**Board of Adjustment
Special Meeting Agenda
Fraser Town Hall, 153 Fraser Avenue
Wednesday February 26, 2025
5:30 PM - 6:30 PM**

a. Appeal Of Administrative Variance Denial - The Ascent

MAJOR SITE PLAN
THE ASCENT

RE: The Ascent – Final Plat, Major Site Plan, Administrative Variance
Planning Review Comments (1st Referral Review)

LIGHTING PLAN
January 29, 2025
SHEET 13

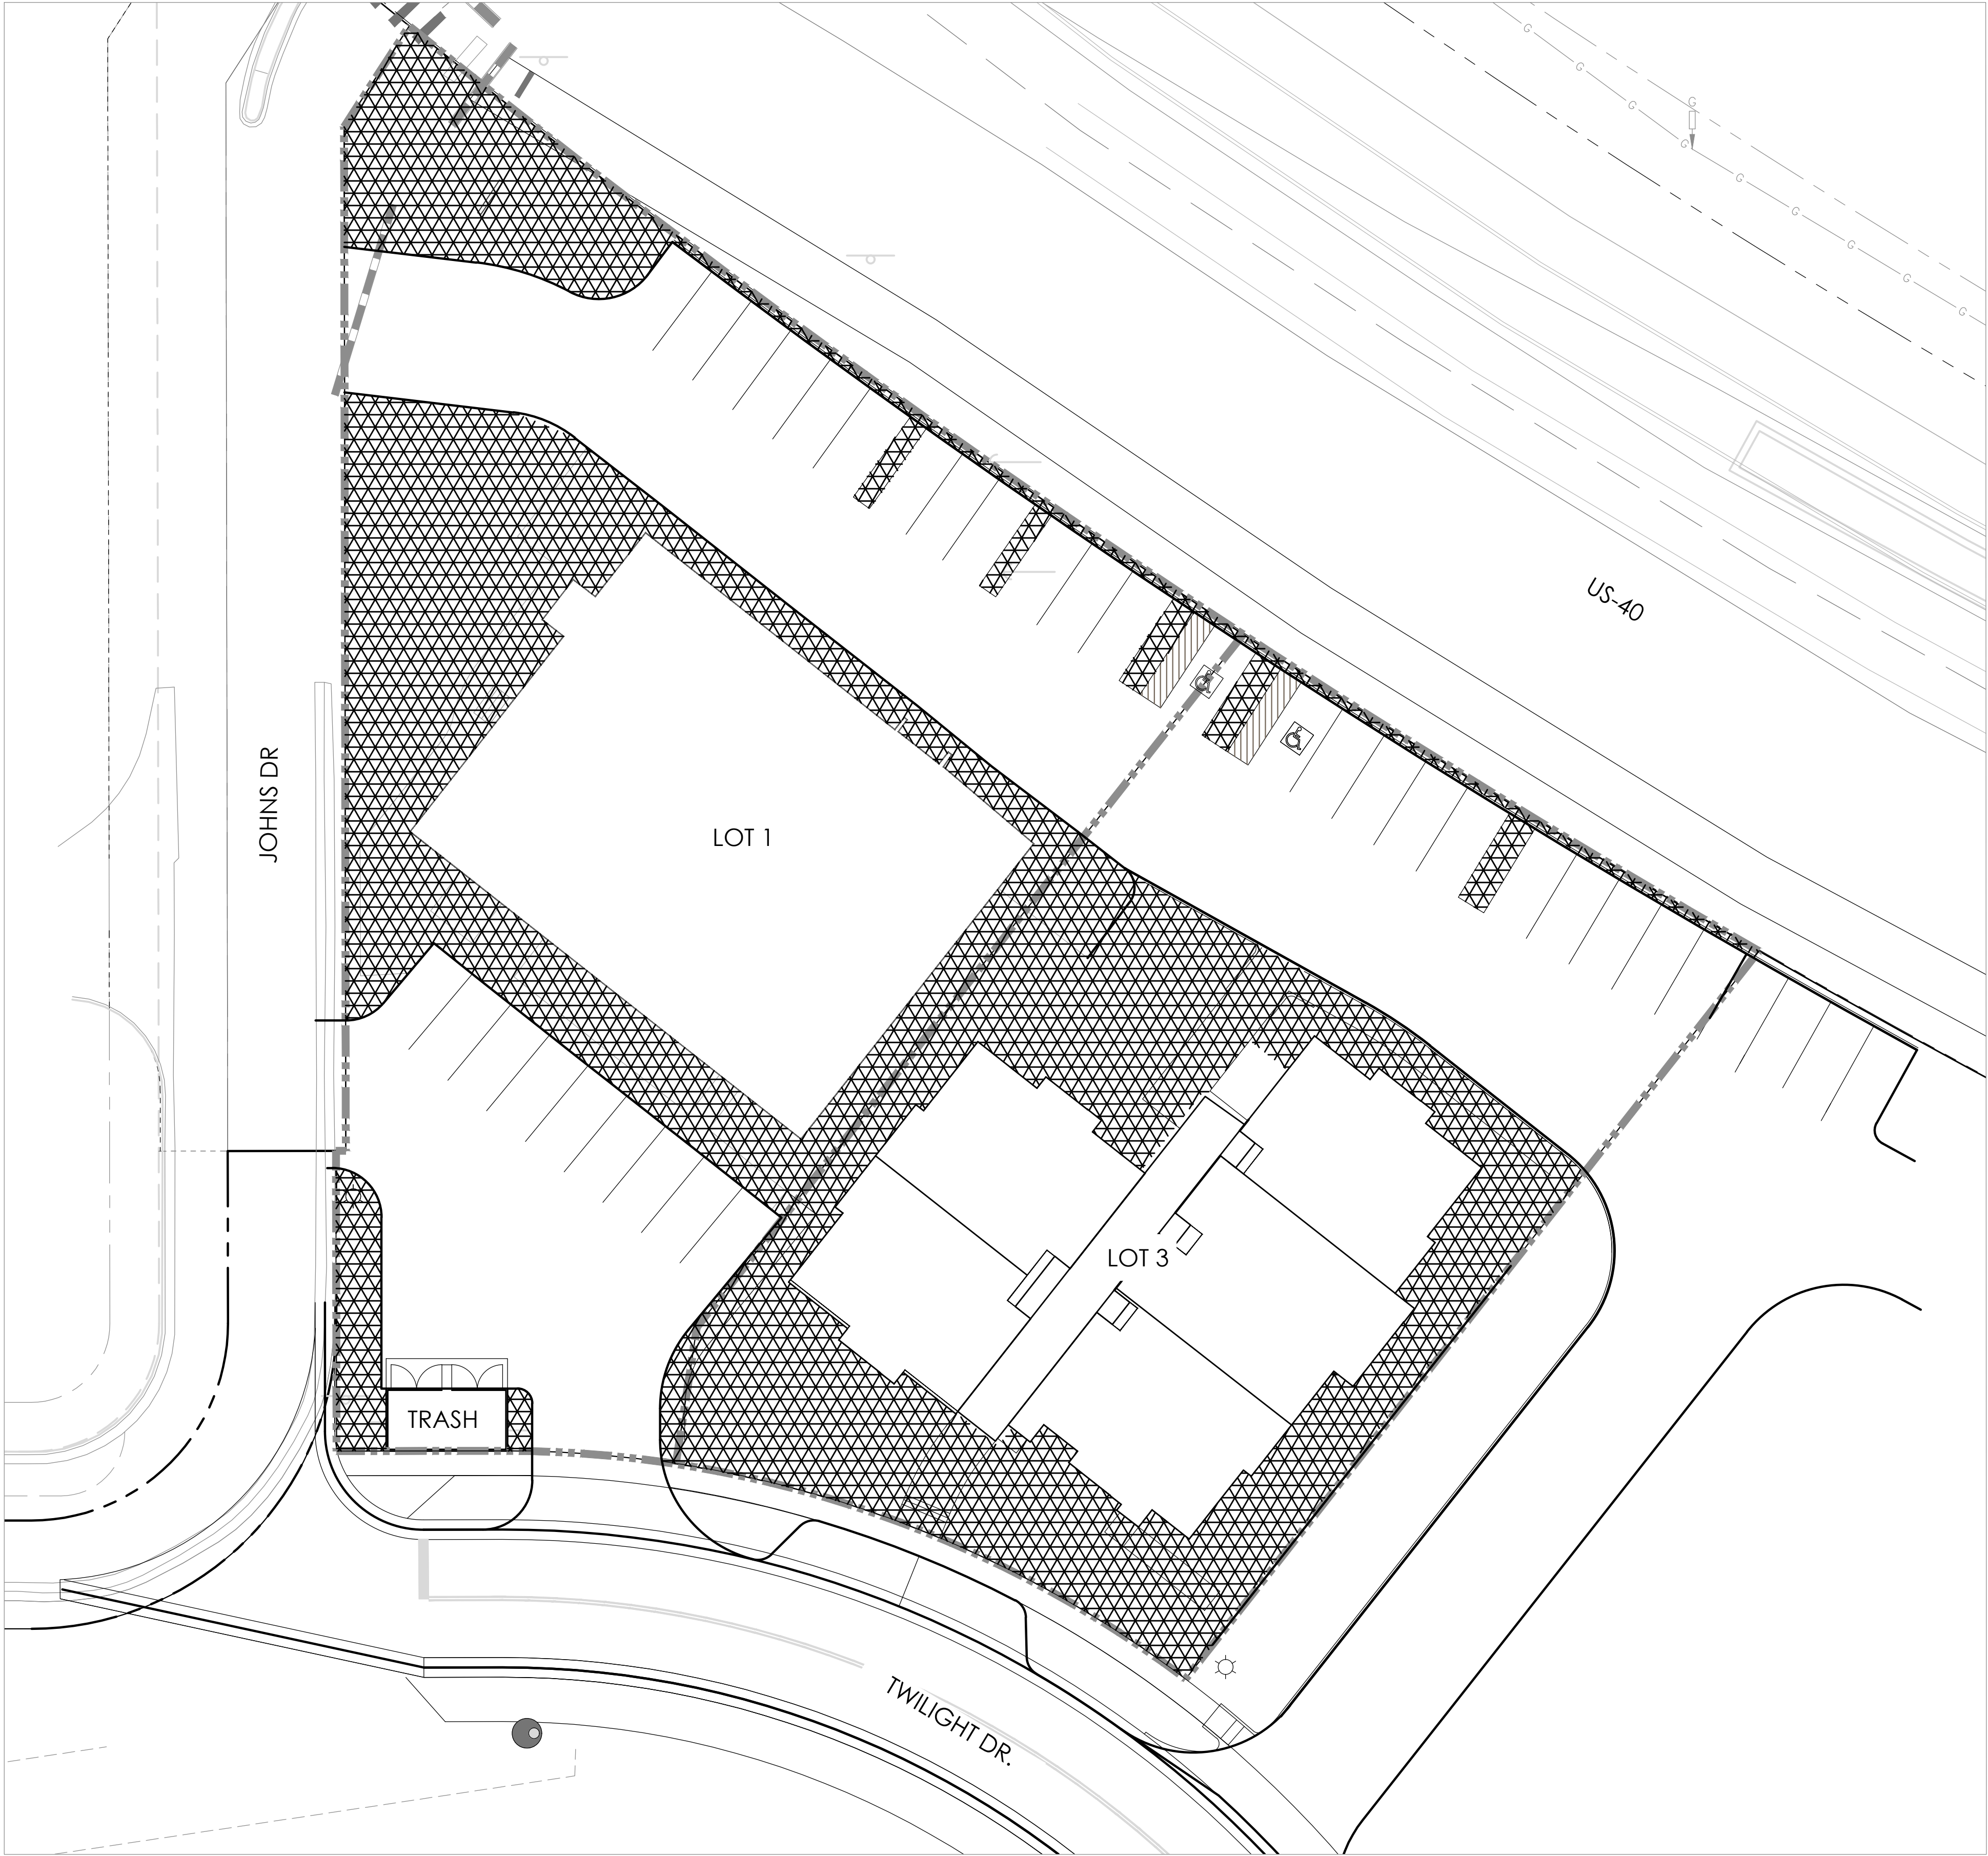
Sheet 12 – Lighting Plan

- 39) [Sec. 14-5-30](#) and [Sec. 19-4-195](#) include site lighting requirements and guidance for sites in the Business District zone. Lighting is to be appropriate for public safety and security, while minimizing undesirable effects of excessive illumination such as glare, sky glow and light pollution.
- a. The lighting plan provided only depicts existing pedestrian and parking lot lighting on the east side of the site. Please update the plan to include detail sufficiently addressing items 1 through 8 in Sec. 14-5-30.
 - b. You may incorporate the photometric plan as required in item (8) into this sheet.
 - c. Additional parking lot lighting is suggested for the southwest and southeast parking areas to provide minimal levels for pedestrian safety.
 - d. Please be sure to include any exterior lighting that is to be provided on the building exteriors into this sheet.
